ECN/PCN No.: M1675
For Manufacturer

Product Description: 10/100/1000 Base-T Single Port, Traditional SMD LAN Transformer	Abracon Part Number / Part Series: ALANS10001	<input type="checkbox"/> Documentation only <input checked="" type="checkbox"/> Series <input checked="" type="checkbox"/> ECN <input type="checkbox"/> Part Number(s) <input type="checkbox"/> EOL
Affected Revision: B	New Revision: C	Application: <input type="checkbox"/> Safety <input checked="" type="checkbox"/> Non-Safety

Ink marking

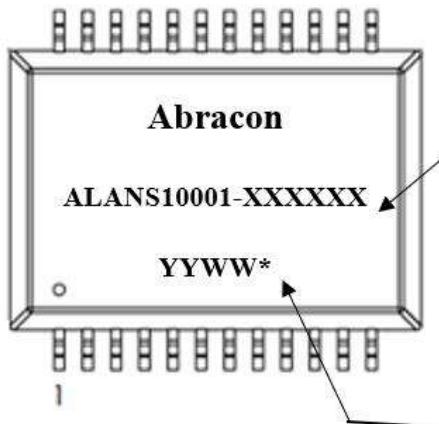
Prior to Change:

To update marking details from Ink marking to laser marking

Laser marking

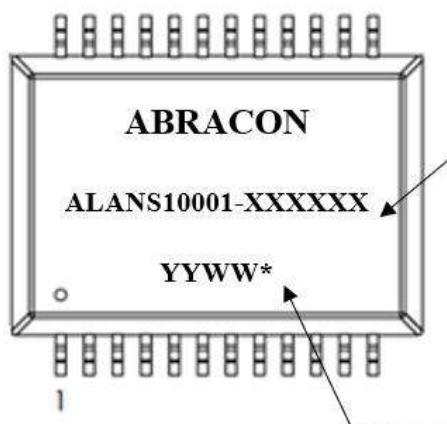
After Change:

Laser marking provides better clarity and durability compared to ink marking

This is a cosmetic change only, marking method updated from ink to laser. There is no change to form, fit, or functionality of the product
